# COUNTY OF SANTA CRUZ

**Subject: 3-Lot Minor Land Division 06-0149 (Marlo)**

# **Revised Drainage Calculations**

**Application Number 06-0149  
Planning Commission Hearing  
1/14/09**

PROJECT	SD1
DATE	1/10/08
SCALE	1"=20'
DESIGNER	SS
CHECKER	SS
APPROVAL	SS
ASSIGNMENT	038-083-11
ASSIGNMENT	PARCEL NUMBER

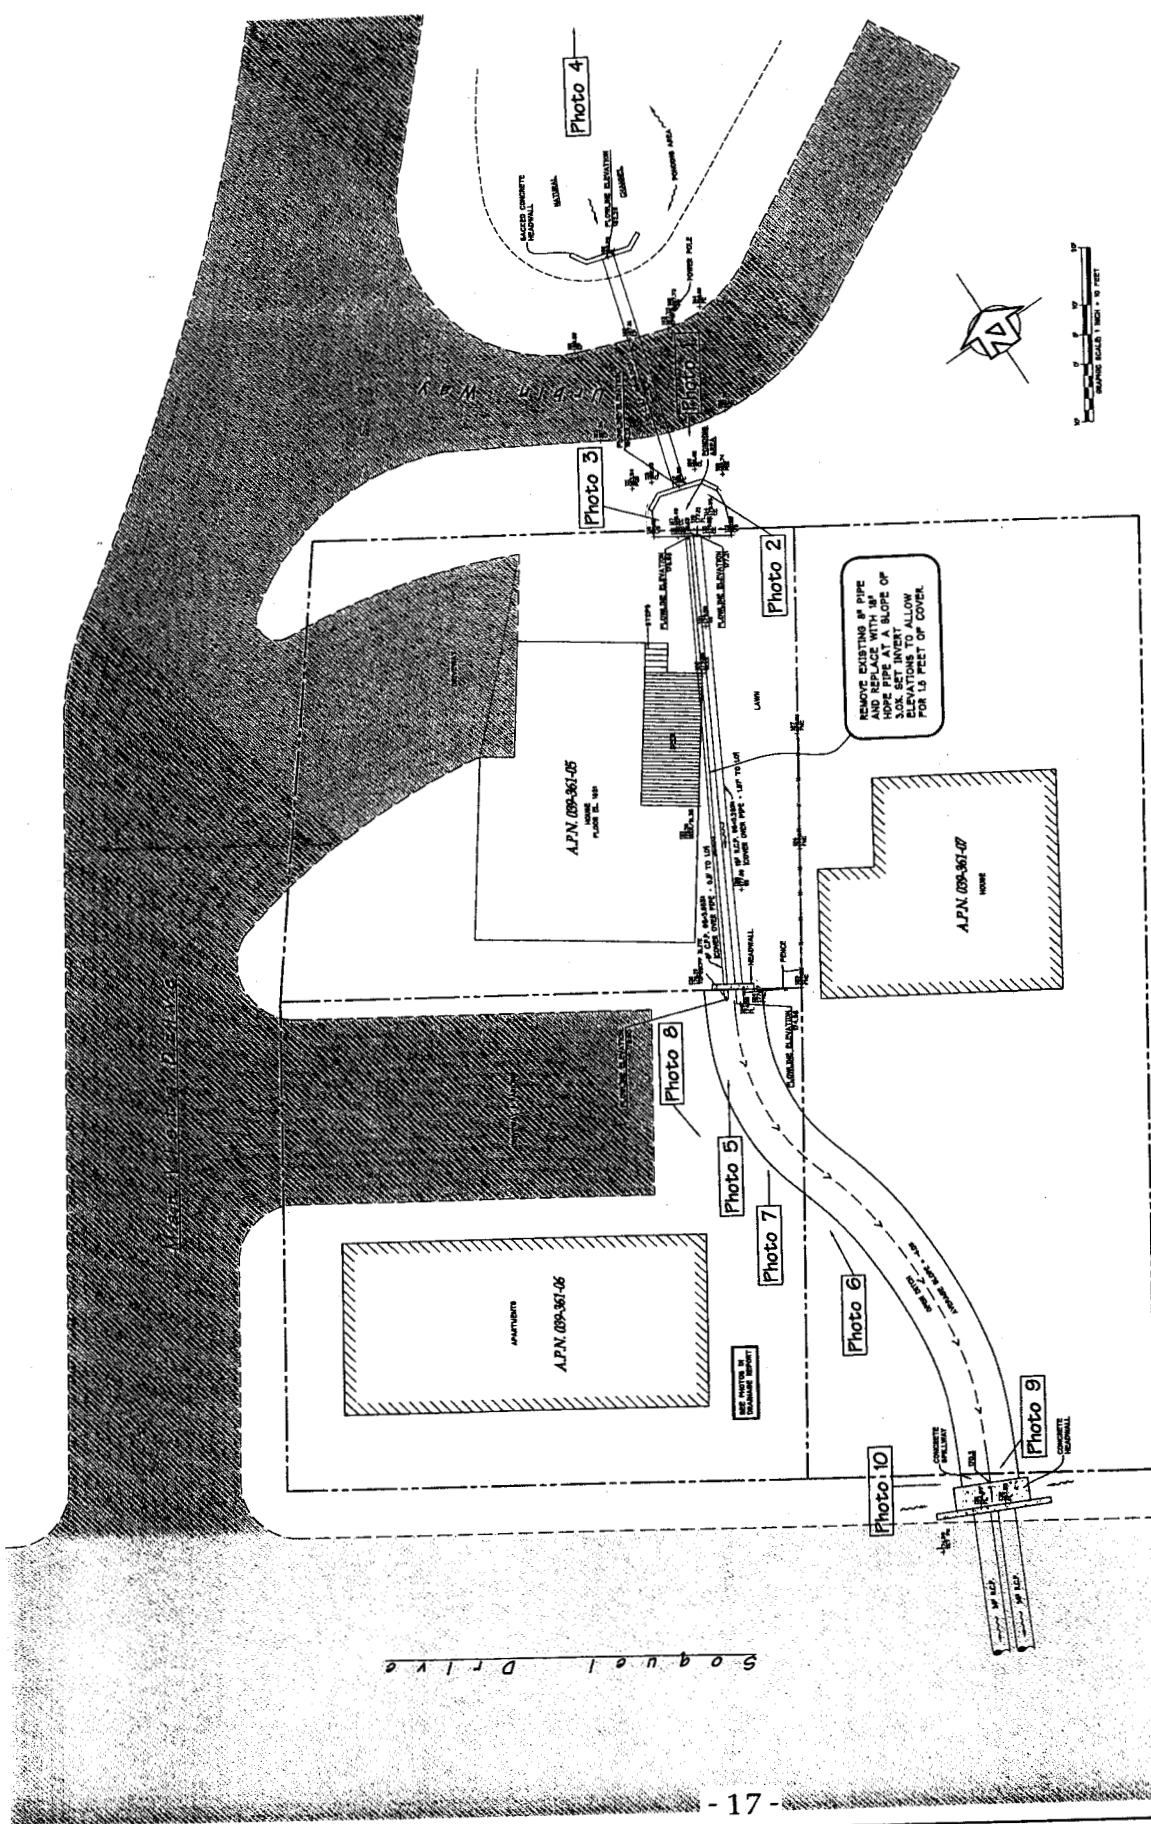
(See attached photos and Sheet D-1 that shows the existing conditions.)

The pipes through the private yard, (15" and 8") have a flow capacity of only about 12 c.f.s. These pipes are well undersized for handling the anticipated flow. If the 8" pipe is removed and an 18" H.D.P.E. pipe were installed parallel to the existing 15" pipe at a slope of 3.0%, the total capacity of both pipes would be 29.84 c.f.s. This would solve the restricted flow capacity situation. Mr. Herkomer, the property owner has stated that he has lived at this location for the past 15 years. The two pipes through the yard were installed by a previous owner. During the past 15 years, Mr. Herkomer has not witnessed any flooding of his yard. He has seen the flow through the 24" C.M.P. pond in the area upstream of the 15" and 8" pipes, but that these pipes have been able to handle the flow. However, he has agreed to allow a parallel pipe be installed to provide for the full designed flow.

APPLICATION NUMBER 06149  
ASSESSORS' PARCEL NUMBER  
039-083-11  
DATE 04/23/08  
SCALE 1" = 30'  
SHEET 1 OF 2

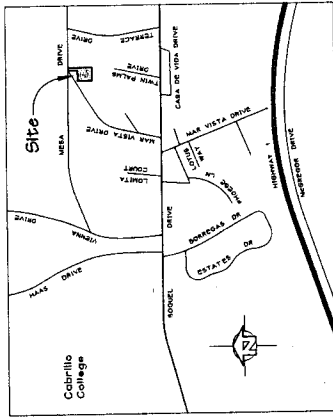
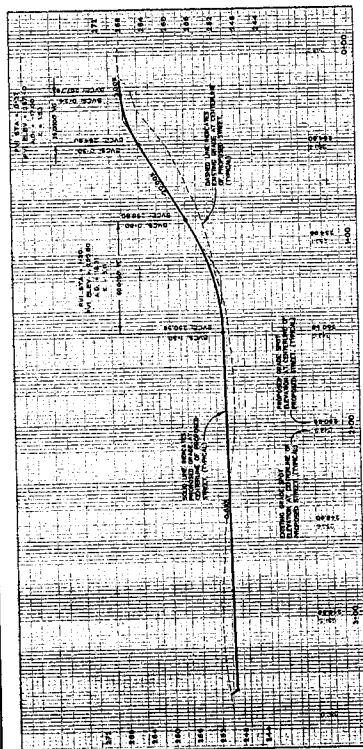
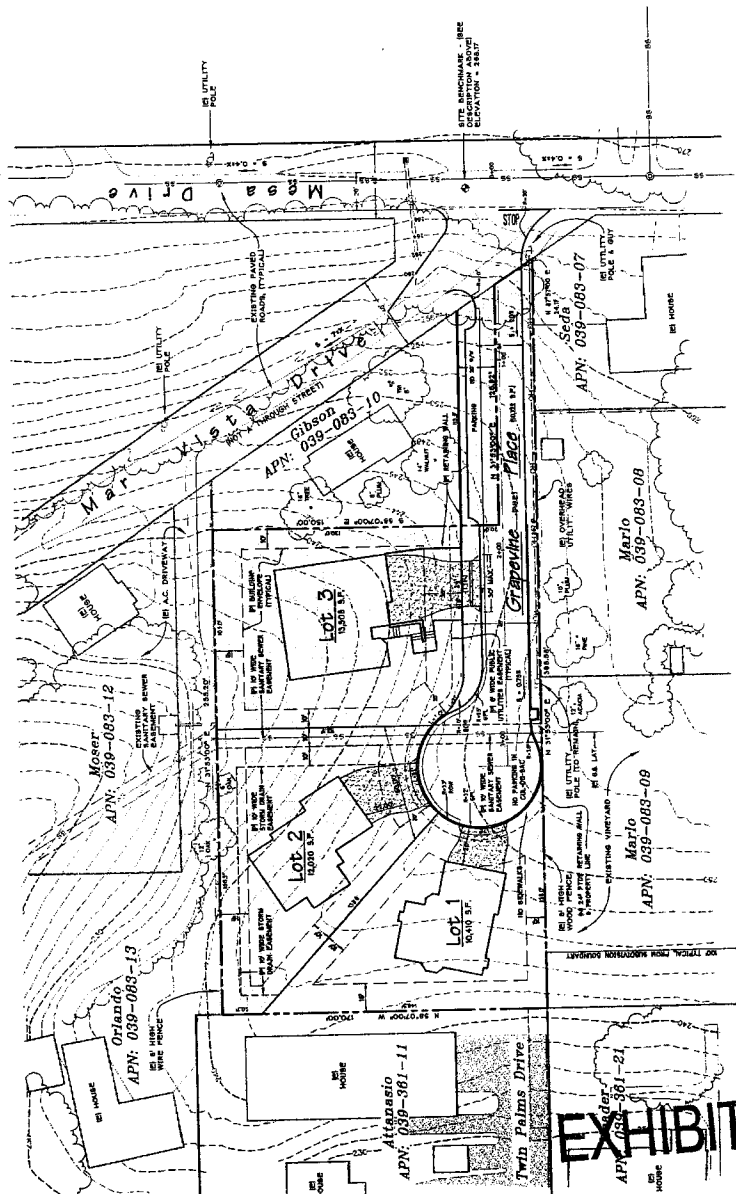
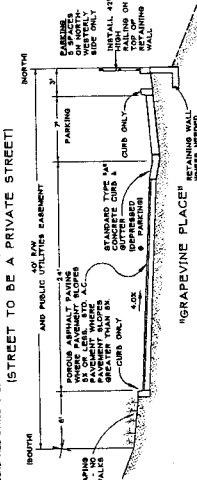
Please provide the information requested above. Also, remove the note below the earthwork quantity estimate on Sht TM2 since it is inaccurate. Only the excavation volume for the structural foundation itself is exempted from ordinance requirements. "Excavation below existing grade" or over-excavation / recompaction volumes are not exempted.

Proposed retaining walls are depicted differently on Sheets TM1 & TM2. Resolve these differences such that the design is consistent. Provide the proposed top & bottom wall elevations at all critical points in the walls. Also provide a typical construction detail for the retaining walls.

As previously requested, please provide a construction detail for the proposed drainage outlet energy dissipator. This is an important element of the Erosion Control Plan and needs to be depicted as to type and location. Please note that the proposed "SD controlled release CB" has a higher invert elevation than the upstream CB to the south. Also the detension pipe segment on Lot 3 is designed with no fall. Please verify design.

1. Submit a plan review letter from the soils engineer.
2. Sheet TM2 has a note stating "Construct Retaining Wall" on the east side of Grapevine Place. There are no details of this retaining wall and it is not clear why it is needed. Please clarify / add information on the plans as to the height and length of the wall.
3. It appears that a low retaining wall is needed at the east side of the proposed cul de sac. Proposed grades show 250.11, but existing grades at the property line are approximately 252.5. Show the length and height of the wall or revise grades accordingly.

3. Plans must clearly show how drainage will be directed away from the SE side of the proposed house on lot 2.
4. Revise the geotechnical notes on Sheet TM2 from "shall be included on the final site grading and improvement plans" to "are incorporated into these plans."
5. Show the limits of grading line.
6. Include grading x-sections through the proposed structures that are perpendicular to the one shown.
